Technical Service Bulletin

No. D71-14-2

Engine Surge
and Stumble
Caused By
Warped
Air Horn

MODELS: 1968,
1969, 1970
and 1971
Models Equipped
With 383-2 bbl.
Engines and
1-1/2" BBD
Carburetors

CARTER BBD 1-1/2" AIR HORN CORRECTION

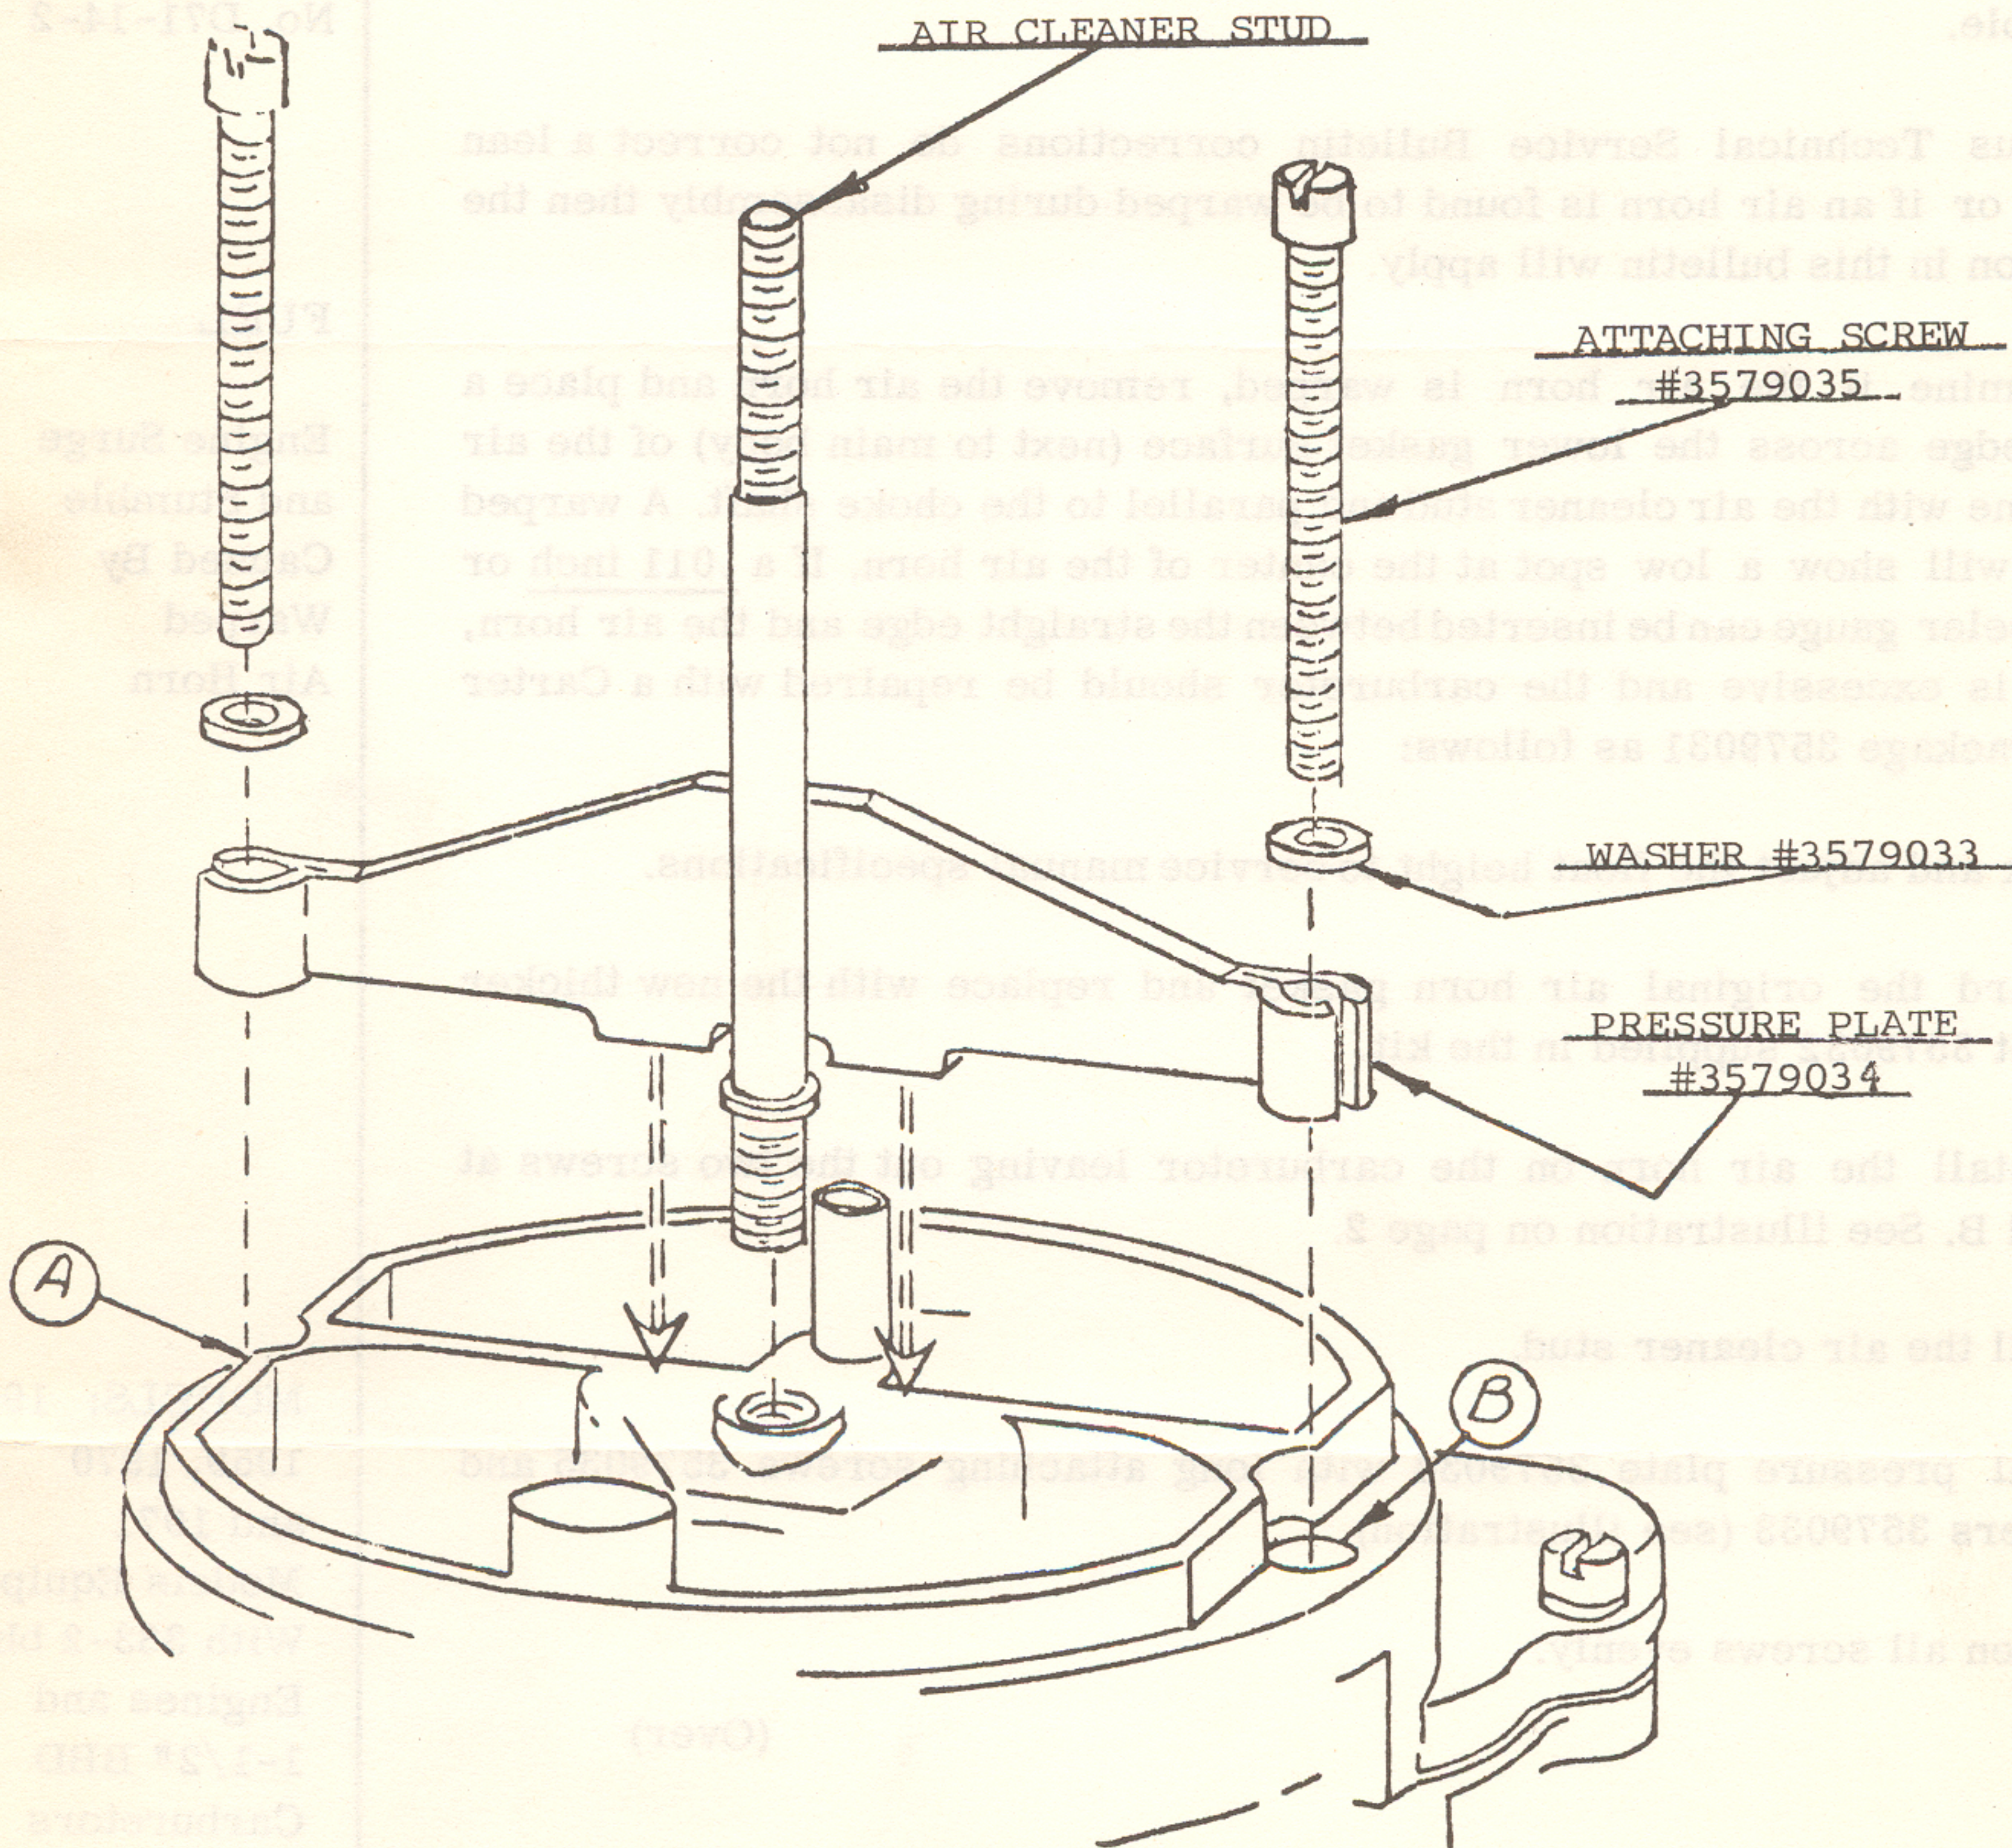
A warped air horn on the 1-1/2" BBD Carter carburetors as used on the 383-2 bbl. engines may cause a lean mixture and result in complaints of surge and stumble.

To determine if the air horn is warped, remove the air horn and place a straight edge across the lower gasket surface (next to main body) of the air horn in line with the air cleaner stud and parallel to the choke shaft. A warped air horn will show a low spot at the center of the air horn. If a .011 inch or thicker feeler gauge can be inserted between the straight edge and the air horn, warpage is excessive and the carburetor should be repaired with a Carter Service Package 3579031 as follows:

1. Check and adjust the float height to service manual specifications.
2. Discard the original air horn gasket and replace with the new thicker gasket 3579032 supplied in the kit.
3. Reinstall the air horn on the carburetor leaving out the two screws at A and B. See illustration on page 2.
4. Install the air cleaner stud.
5. Install pressure plate 3579034 with long attaching screws 3579035 and washers 3579033 (see illustration).
6. Tighten all screws evenly.

7. Check the accelerator pump and bowl vent setting.

At the time of these repair operations, the accelerator pump delivery should be checked. If two strong streams of fuel are not squirted across the venturi when the throttle is opened at a moderate rate, corrections should be made by flaring the pump leather, installing a new plunger, checking the check ball seat, or cleaning dirt from the discharge passages depending on the nature of the defect.
